Reply to Correspondence Reference Number: 12808

731 Confirmation Number: EA96729

Applicant: Spike Technologies, Inc

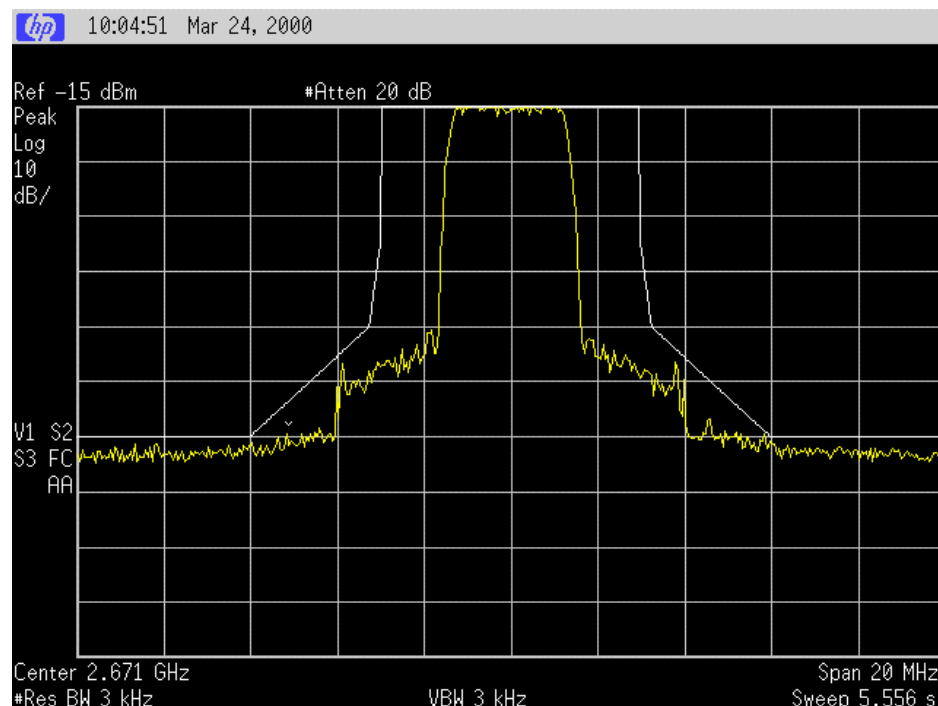
3.) The modulated spectrum plots included as Pages 15 and 18 show non-compliance with the emissions emissions when adjusted for the average (or "flat top") signal level of the emission(s). Please indicate how the units will be modified to show compliance.

4.) Use of a spectrum analyzer RBW of 3 kHz for the "Sub" plot would not be permitted without adjustment of the emission attenuation requirement by the ratio to the average or "flat top" reading.

The modulated spectrum plot shown in Figure 18 used the "relative power measurement (below flat top)" specified in 21.909 (e) (2). We could not apply the absolute measurement due to the burst nature of the upstream modulated signal. In this method, the "flat top" is adjusted to the reference level of the analyzer. Because the modulated spectrum is a burst signal, if the analyzer were placed in max hold over enough samples, the peaks would fill in to make the signal more flat topped and the position of the plot would be correct as is. Another plot was taken in max hold and is submitted below:

A second "Sub" plot is submitted above in our reply to Item 3. This plot was taken with a RBW of 3 kHz. It is our understanding that item 4 is addressed by demonstrating that the position of the "flat top" is placed correctly.
